Access Compliance Report

Public Rights-of-Way

Intersection ID: 42550	Main Street: ENEIDA_SUE_DR	Cross Street: JOANNAS_CT	Location: E
ADA ID: C389B770AD8B	Ramp Type: PerpDiag	Initial Pass/Fail: Fail	Overall Compliance: No
Severity Score: 22.5			
Codes/Mitigation Info/Possible Solution		Field Measurements/Component Compliance

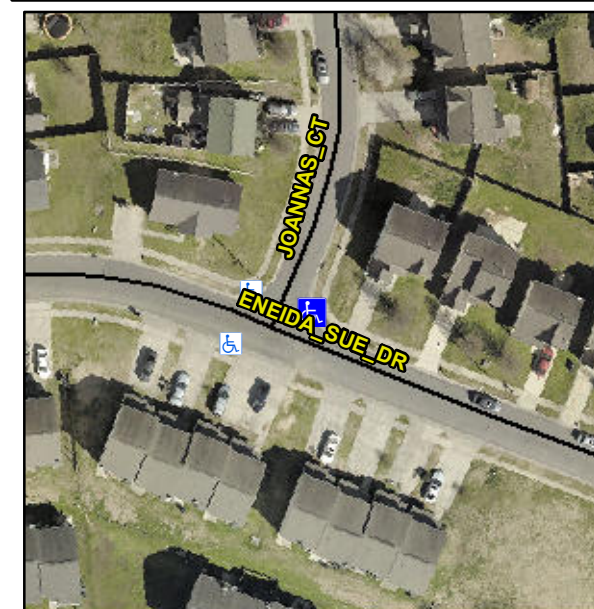
Not Found, R304.5.1, R304.2.2, R304.5.3

Compliance	Description	Data	Compliance	Description	Data
N/A	Ramp Length (in)	51.0	No	Ramp Slope (%)	9.2
No	Ramp Width (in)	38.5	No	Ramp XSlope (%)	4.2
N/A	Flare Type LT	N/A	N/A	Flare Type RT	N/A
N/A	Flare Slope LT (%)	N/A	N/A	Flare Slope RT (%)	N/A
N/A	Flare Traversable LT?	N/A	N/A	Flare Traversable RT?	N/A
N/A	Landing Length (in)	N/A	N/A	DWS Provided?	N/A
N/A	Landing Width (in)	N/A	N/A	DWS Contrast?	N/A
N/A	Landing Slope (%)	N/A	N/A	DWS Length (in)	N/A
N/A	Landing X Slope (%)	N/A	N/A	DWS Full Width?	N/A
N/A	Landing Curb? (Y/N)	N/A	N/A	DWS Offset (in)	N/A
N/A	Shared Landing?	N/A			
N/A	Gutter Ponding?	N/A	N/A	Gutter Slope (%)	N/A
N/A	Gutter Lip Ht (in)	N/A	N/A	Gutter X Slope (%)	N/A
N/A	Painted X Walk1?	No	N/A	Painted X Walk2?	No
	X Walk 1 Direction	To NW		X Walk 2 Direction	To SW
N/A	X Walk 1 Width (in)	N/A	N/A	X Walk 2 Width (in)	N/A
	X Walk 1 Slope (%)	4.3		X Walk 2 Slope (%)	1.1
	X Walk 1 X Slope (%)	2.9		X Walk 2 X Slope (%)	3.1

Remove & Replace Curb Ramp With Two New Directional Ramps or Equivalent.
